PROPOSED CHANGE NO. 3

SOUTHWEST EXPERIMENTAL FAST OXIDE REACTOR

Re: LICENSE DR-15

Proposed Change No. 3
for the
Southwest Experimental Fast Oxide Reactor

FIGURE 1
LINEAR POWER DENSITY
VS
APPARENT REACTOR POWER

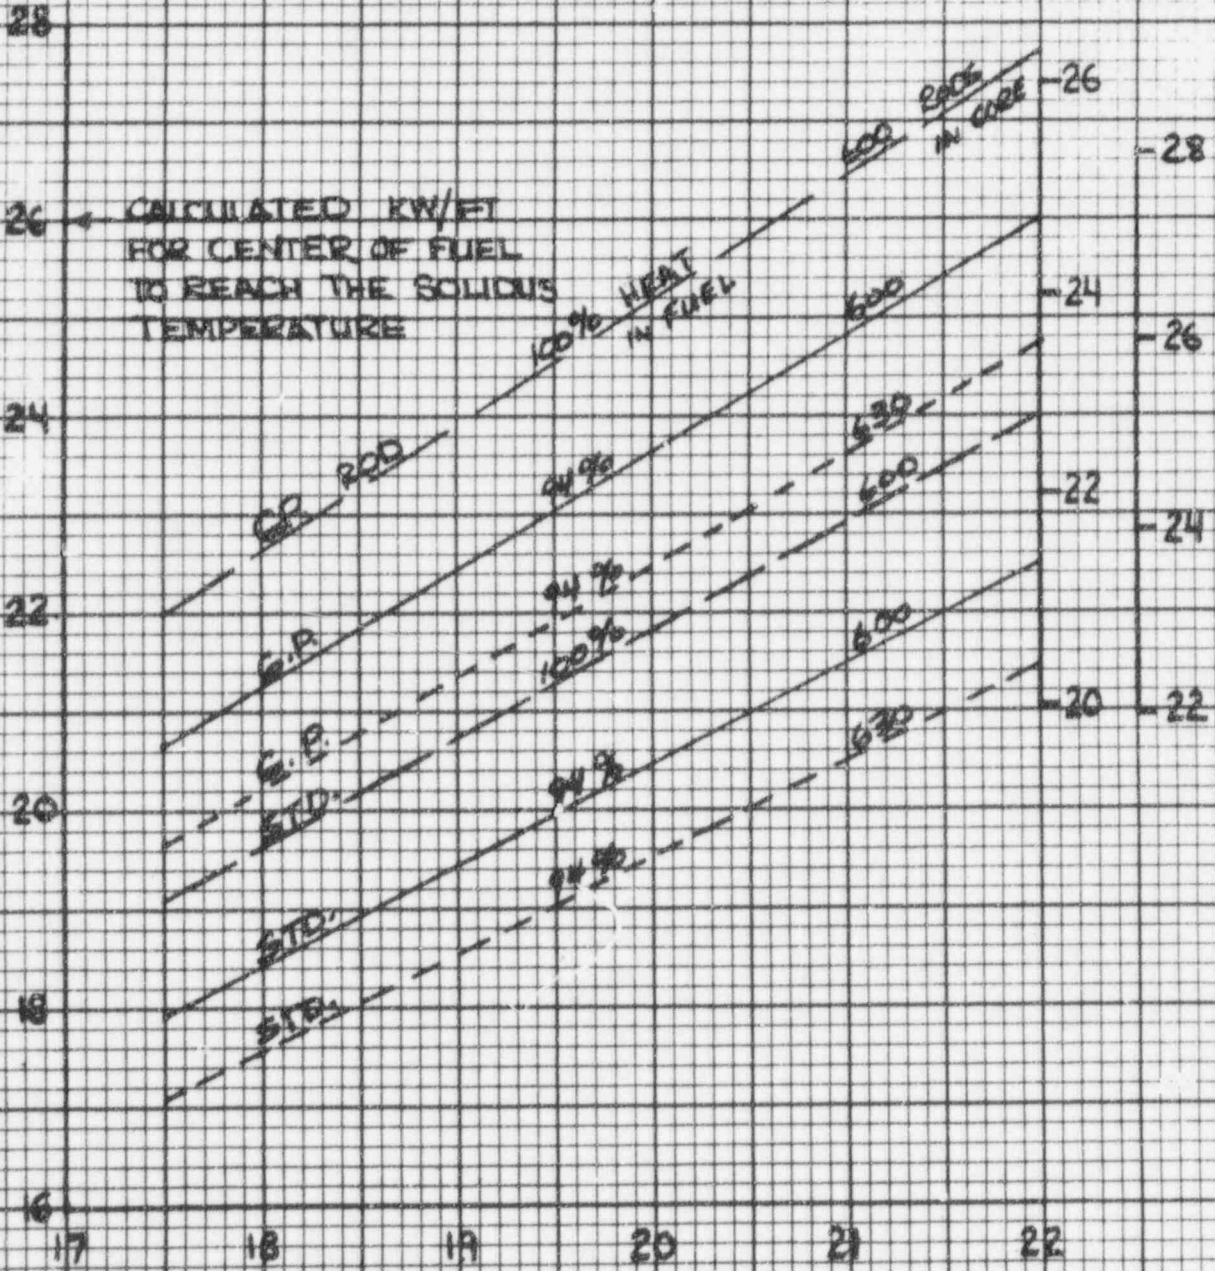
effects of using 630 fuel rods and 94% heat generation for linear power density calculations are illustrated in Figure 1.

The uncertainty in reactor heat balance data must also be considered. The effect of the maximum expected error of +5% in heat balance data is shown by the different scale factors on the right side of Figure 1. Thus, if the heat balance data are 5% high at an indicated reactor power of 20 MWt, the true linear power density for a given fuel rod will be 5% lower than the calculated value, and vice versa.

Using the curve for 630 fuel rods and 94% heat generation, Figure 1 indicates that the guinea pig rods under the innermost ports at 20 MWt reactor power will operate at a linear power density of 22.6 KW/ft with nominal heat balance data, or at 23.7 KW/ft if the heat balance data contain the maximum expected error of 5% on the low side. These power densities are within the safe operating region presently recognized by the Technical Specifications.

The present power limits in the Technical Specifications were chosen to provide assurance that fuel melting would not occur in any of the fuel rods. This assurance will remain in effect for all fuel rods in the core except those guinea pig rods (maximum of six) located under the innermost ports. These guinea pig rods may experience some central fuel melting if the combination of parameters which determine this is unfavorable. However, operation with the expected core loading and with nominal values of calibration data and fuel parameters would not result in fuel melting at the reactor safety limit of 22 MWt. (See Figure 1).
